# SCOTTSDALE ENTRADA

# **Basis of Design Report**

**FINAL Basis of Design**

Re: Scottsdale Entrada Basis of Design Reports - Comment Response Letter

# WATER PLANS FOR

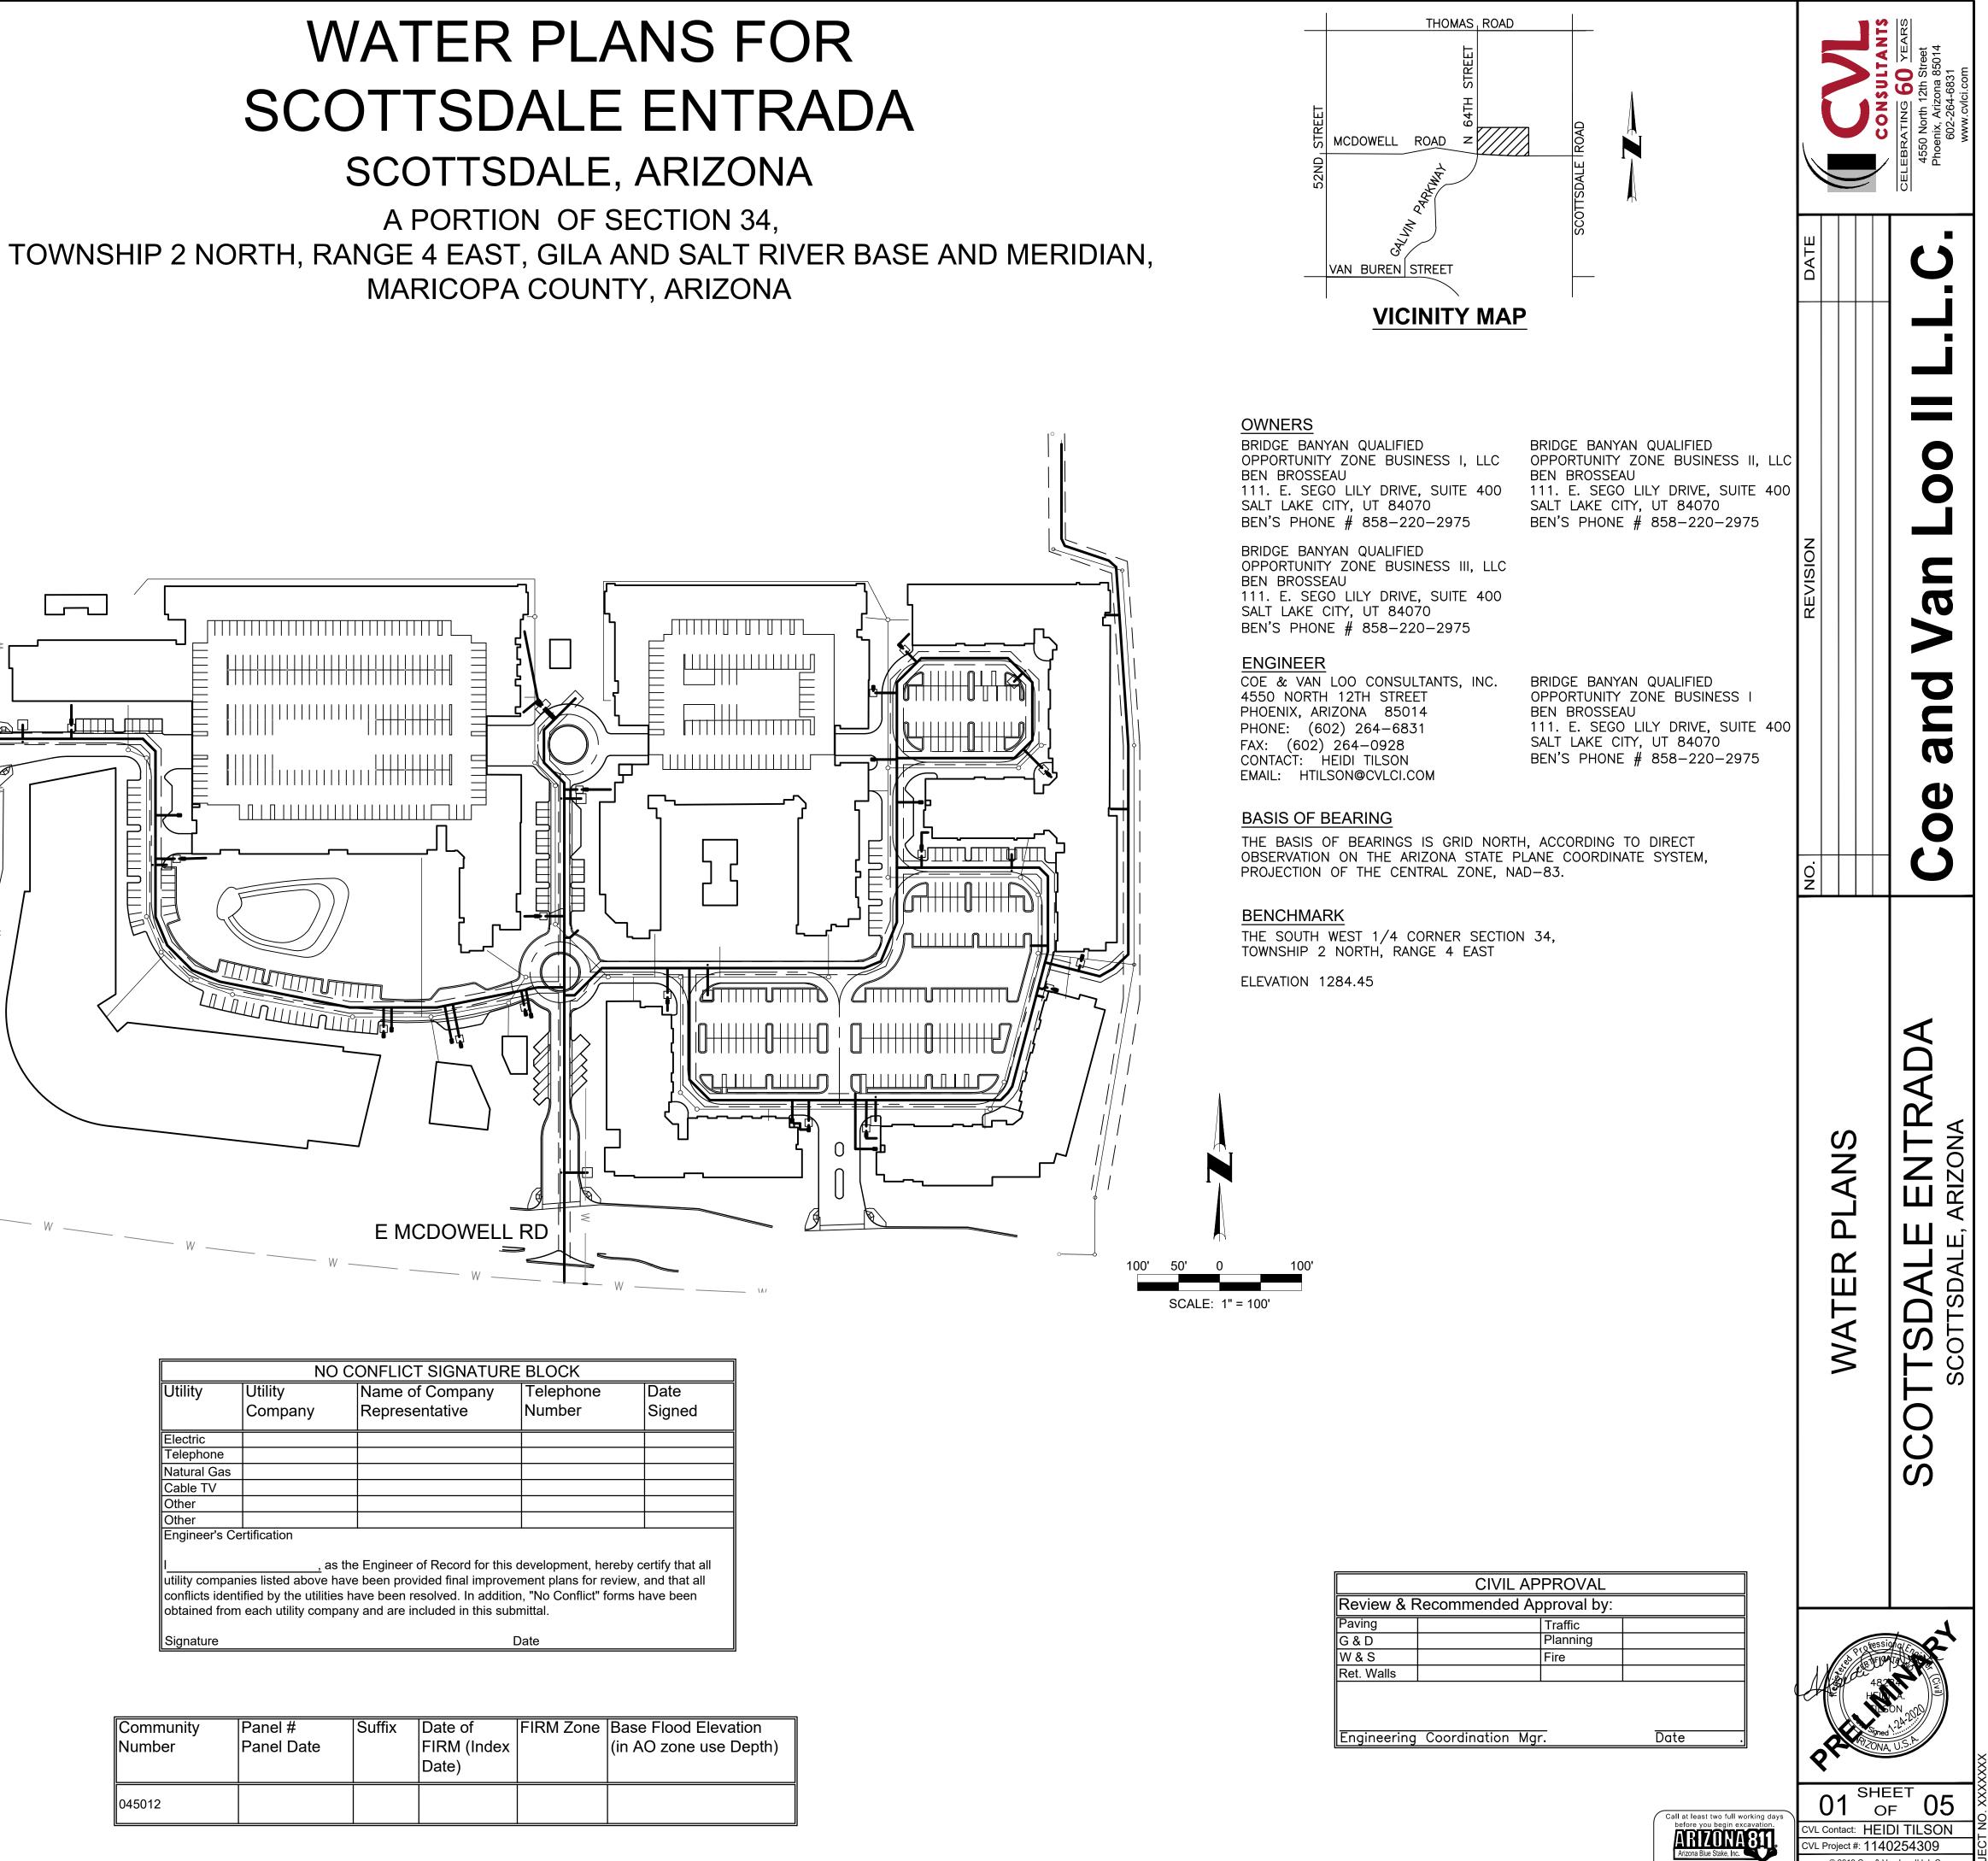
Address comments below and herein on plans:

1) equal size connections to existing mains must be done with full size tees not tapping saddles. Section of ACP pipe main must be replaced with DIP at these connections.

2) Plans herein are not approved in detail

3) Easements for meters must extend out from water main easement and include service line

4)confirm hydrant placement and spacing with fire department. same for riser rooms.

5) final meter size to be per IPC 2015 fixture count with 1.5 factor applied, then use DS&PM table to size meter. All meters 3" and greater require a vault per COS detail 2345

*Response: The above comments are being addressed as part of the final design. A draft of the final water plan is attached for reference.*
